PRODUCT/ PROCESS CHANGE NOTICE

Number: 2221-1
Date: 10/13/2022
ECO#: TBD
ECO Ref.: (Class: 3 Notification)

Products Affected: 5x7mm T602-series at selected frequencies:

Original configurations:

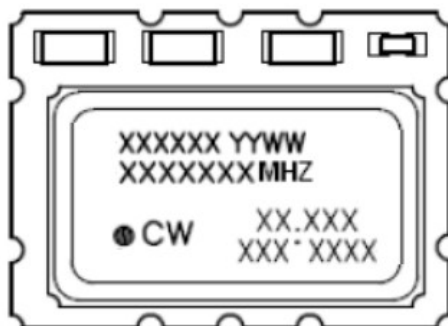
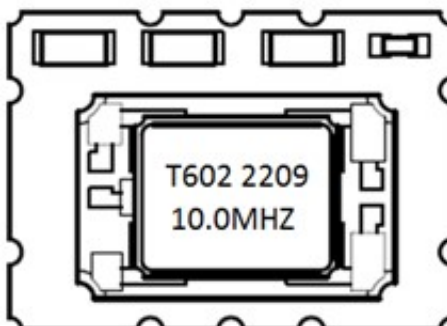
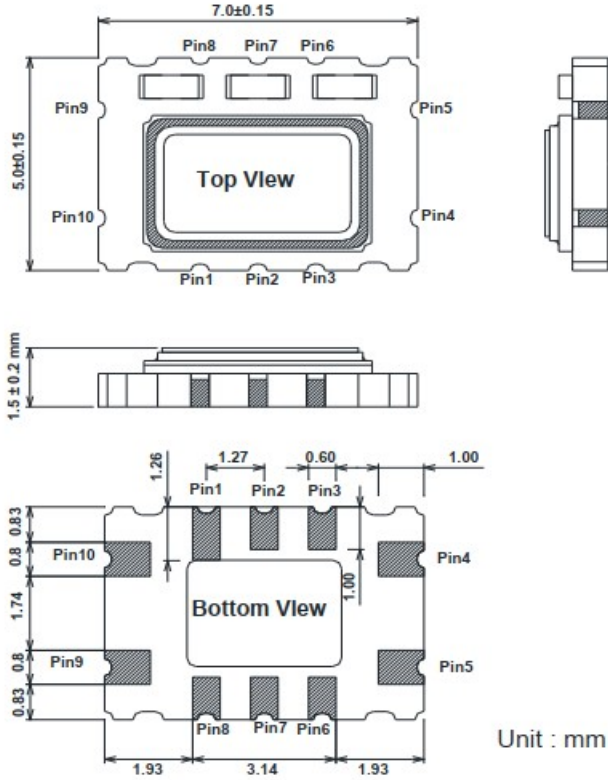
Change Description: Changing package configuration to improve product availability.

Reason for Change: End-of-Life components within the design.

- 1) Electrical performance of the part does not change.
- 2) Bottom pad configuration layout and pin numbering remains the same.
- 2) Height reduction from original configurations of 2.0 or 2.4mm down to 1.5mm.
- 3) Physical changes from 4 components across the top to 3, and added bottom cavity.

New Configuration (1.5mm height):
